Commission of Architectural Review

4. COA-169005-2025	Final Review Meeting Date: 7/22/2025
Applicant/Petitioner	Brian Spencer
Project Description	Construct a new masonry and stone front porch
Project Location	
Address: 17 N Arthur Ashe Boulevard	
Historic District: Boulevard	
<p>High-Level Details:</p> <p>The applicant proposes to reconstruct a full-width front porch. This property is part of a consistent early 20th-century row of houses on the east side of the boulevard. Archival documentation confirms the existence of a full-width porch historically. The reconstruction will involve new masonry piers, a terracotta tile floor system, granite coping and steps, and a new wooden balustrade. The original columns and roof structure are to be retained and repaired with in-kind materials if necessary.</p>	
Staff Recommendation	Approval, with Conditions
Staff Contact	Yara Iwaz, Yara.Iwaz@RVA.gov, (804)646-6031
Previous Reviews	<ul style="list-style-type: none"> N/A

Figure 6

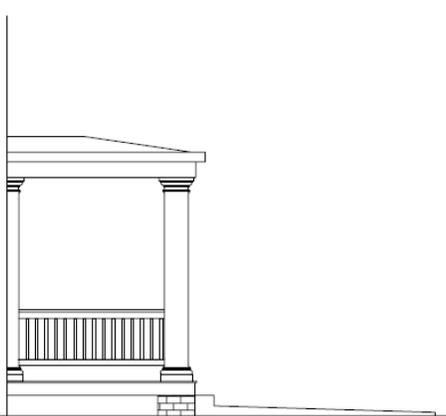
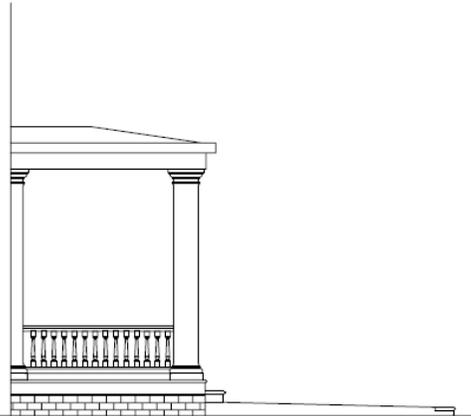
Materials & Colors, page 53	<p><i>2. Materials used in new construction should be visually compatible with original materials used throughout the surrounding neighborhood.</i></p>	<p>The proposal includes terracotta tile flooring, granite treads and coping, and brick piers, which are compatible materials that are found on the porches of the 00-block of AA Blvd.</p> <p><u>Staff recommends approving the material selection; final colors and specifications to be submitted for staff approval.</u></p>
Standards for Rehabilitation, Residential Construction, page 59	<p><i>7. Repair damaged elements instead of replacing them. Use materials that match the original in type or use physically and chemically compatible substitute materials that convey the same appearance as the surviving elements or sections. Use available documentation when reconstructing missing elements. Pictorial, historical, or physical documentation can be helpful.</i></p>	<p>The application specifies that the column height and detailing will remain unchanged, and the railing system will mimic those found at 11–23 N. Arthur Ashe, consistent in height, layout and profile. The balustrade will feature wooden turned posts which is an adequate recreation of the historic porch.</p> <p>While the proposed railing is generally consistent with historic documentation, staff notes a discrepancy between the balustrade turned posts shown in the façade elevation and those illustrated in the detail drawings, specifically regarding the turning profile.</p>

<p><u>Staff recommends submitting final details and profiles of the balustrade and turned posts for staff review and approval.</u></p>
<p>Porches & Porch Details, page 49</p>	<p><i>1. Porch railings and balustrades are important character-defining features of historic buildings. The proportions of these railings are a significant contributing feature to the appearance of both the individual structure and the character of the entire neighborhood.</i></p>	<p>The proposed balustrade will be anchored into the existing column, which is a significant architectural element of the building's historic façade. The existing simple Richmond railing will be removed and replaced by a turned post balustrade. While this configuration is common on the block, any attachment method must be carried out with caution to avoid damaging historic fabric or compromising the column's structural and visual integrity. Additionally, the proposal includes an in-kind replacement of existing porch materials where necessary.</p> <p><u>Staff recommends that all construction activity, including the connection of new balustrade components to existing columns and the removal of the existing railing, be carried out using best preservation practices. Existing historic material should be protected and retained where feasible.</u></p>
